PRODUCT CHANGE NOTIFICATION

Select Bourns® Model PSM Series Motorized Slide Potentiometer

Additional Source of Supply for Motor & Change to Metal Plate, Plate Form and VR Thickness

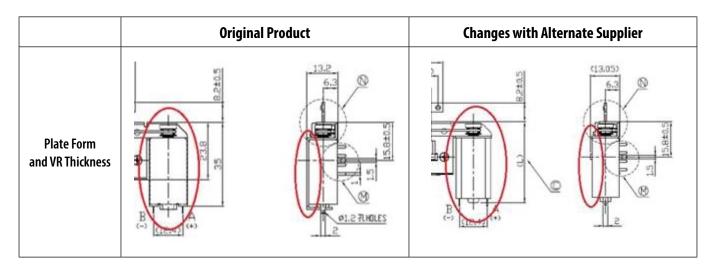
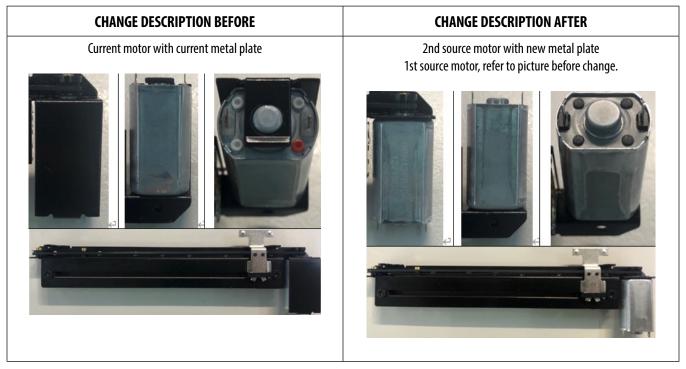
The dimensions of the motor from the additional supplier are slightly longer than those of the original supplier. As such, Bourns will change the metal plate in order to fit motors from both production facilities. The new metal plate will be standard in all Model PSM products regardless of the motor supplier. As provided in the drawings below, the plate form and VR thickness of the products with the original and alternative motor will differ.

Due to the external dimension change caused by the new metal plate on all affected part numbers and the longer motor on products utilizing motors from the additional supplier, the fit of the affected part numbers will change. Due to the plate form, the form of the affected part numbers will change. The function, quality and reliability of the Model PSM Series Motorized Slide Potentiometer remains the same. Traceability is maintained through identification of the motor supplier on the product label.
